SAFETY EVALUATION REPORT

Document Title: Oconee Nuclear Station Unit 3, Abnormal Transient
Operating Guidelines (ATOG)

Document Date: March 23, 1982 with June 25, 1982 Updates

Originating Organization: Babcock and Wilcox Nuclear Power
Generating Division

Figure 2 Operator actions regions for ICC

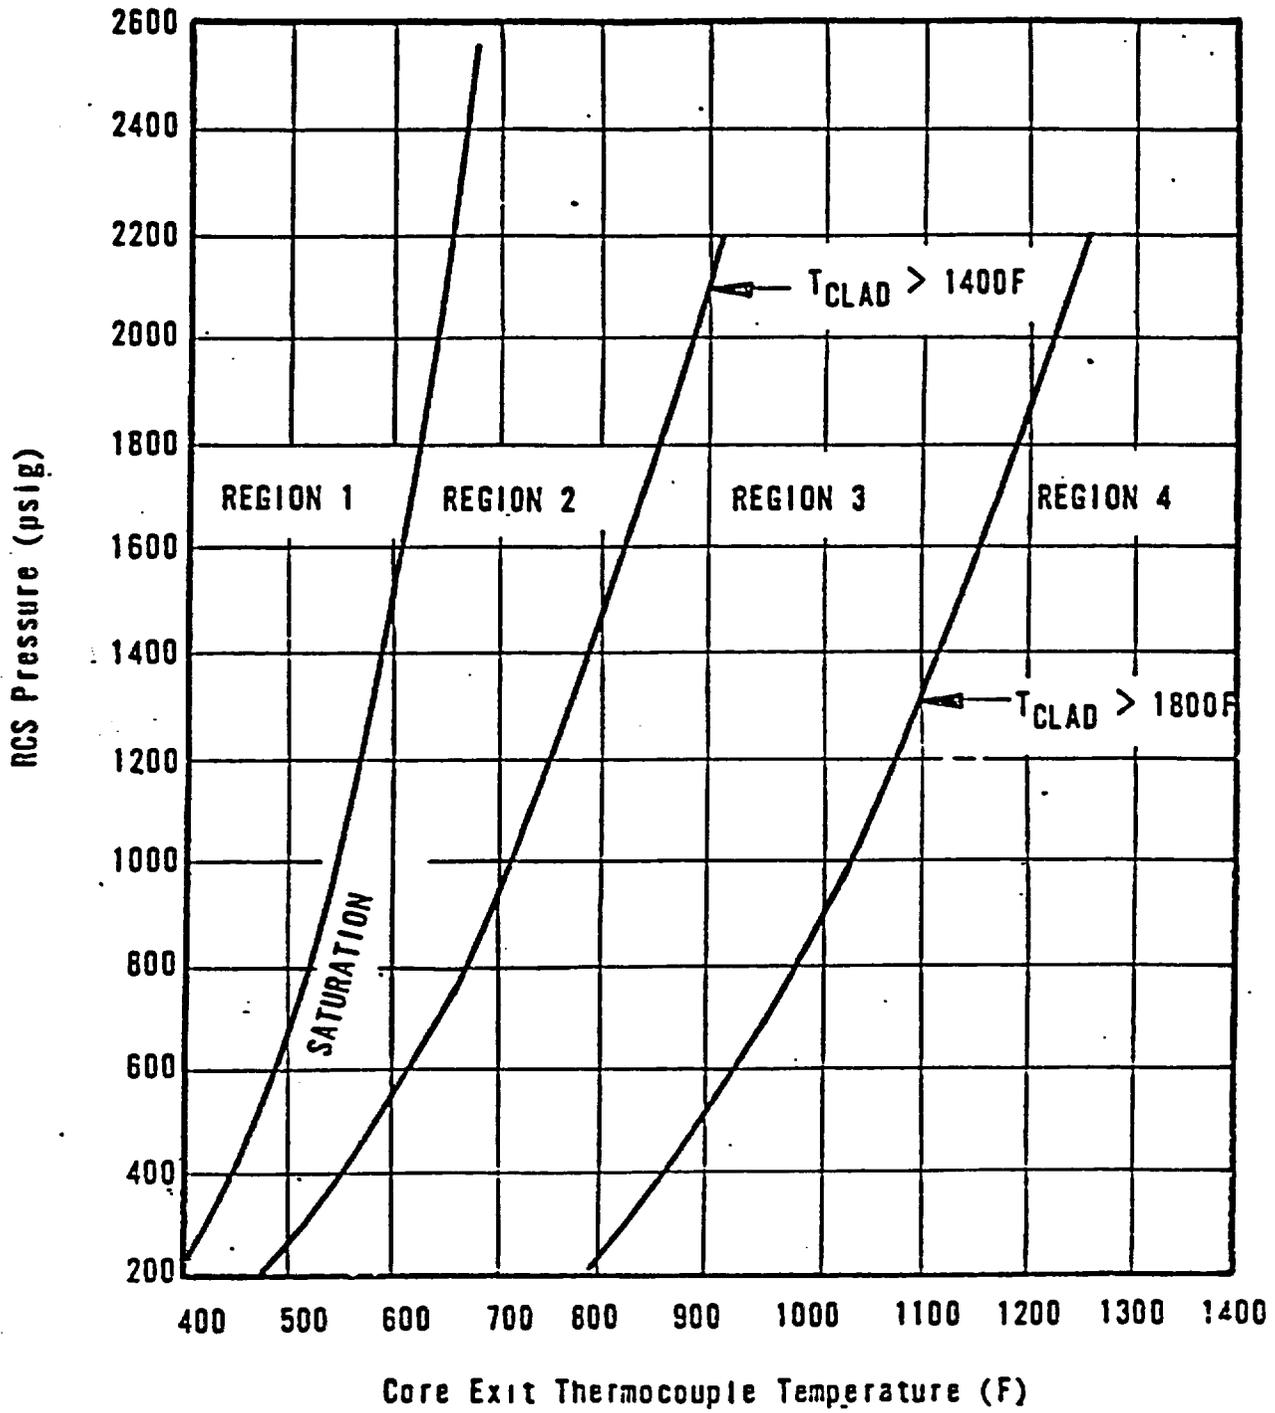
Areas in the ICC guidance which need improvement include:

- (1) Changes to the ICC Section should provide guidance on the use of reactor vessel level/inventory measurement systems becoming operational in B&W plants.
- (2) Additional analytical investigations are needed, as discussed in Section 3.13.

- (3) The Guidelines should provide operator guidance following potential core damage, such as clad degradation, with particular attention given to minimization of releases for such conditions as a SGTR and the use of steam release as a method for control of plant parameters.
- (4) Additional comments regarding RCP operation (Section 3.2.2), voiding (Section 3.4.2), and cooldown (Section 3.9.6) should be considered in providing ICC guidance.

Figure 3 P-T limit curves

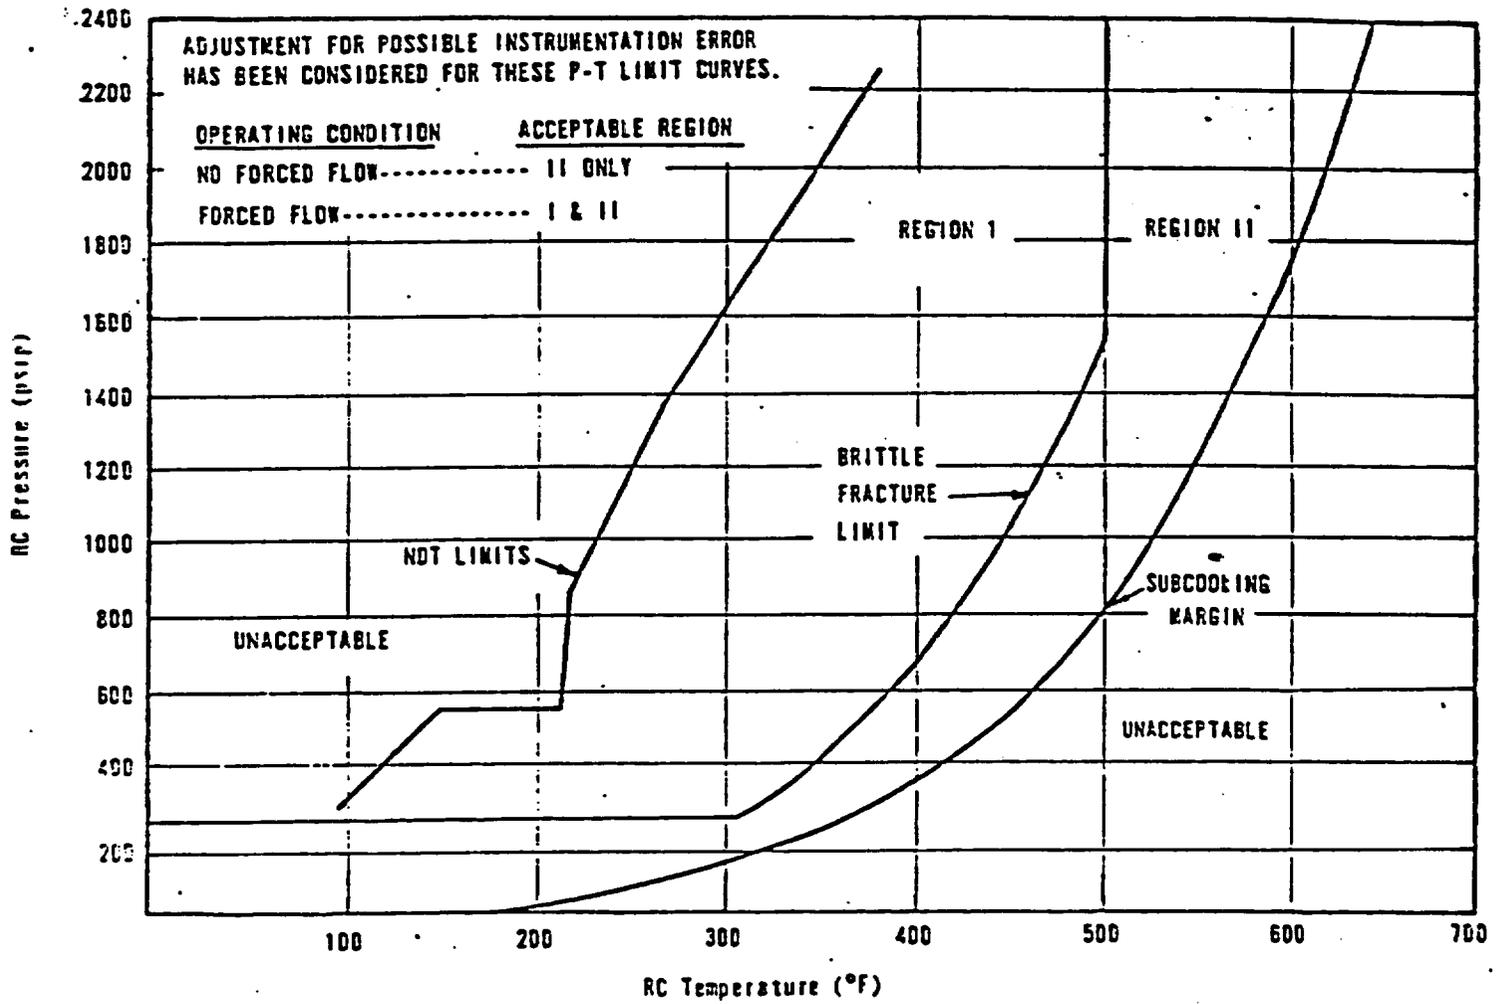
- (1) HPI cooling through the safety valves and PORV with the SG secondary side empty may pose a problem to SG tube integrity. Further investigation of SG temperature distribution, RCS temperature distribution and flow effects (including direction of flow), and resultant tube stress should be performed.

- (2) As stated in Section 3.4.2, the findings of the PTS review may require changes, particularly with respect to pressure/temperature control while in HPI cooling mode.

- (3) The question of whether there are critical restrictions associated with when manual initiation of HPI cooling occurs should be addressed, particularly if degraded HPI conditions or an inoperative PORV exist. Justification should be provided to determine if there are conditions under which HPI cooling is ineffective. The system investigation is necessary to provide RCS flow information pertinent to item (1), above. Additional objectives are to determine expected behavior and determine if different operator guidance is needed with availability of two, one, or no HPI pumps.

Guidance should be provided for the case where pressure-temperature limits, typified by Figure 3, have been exceeded.
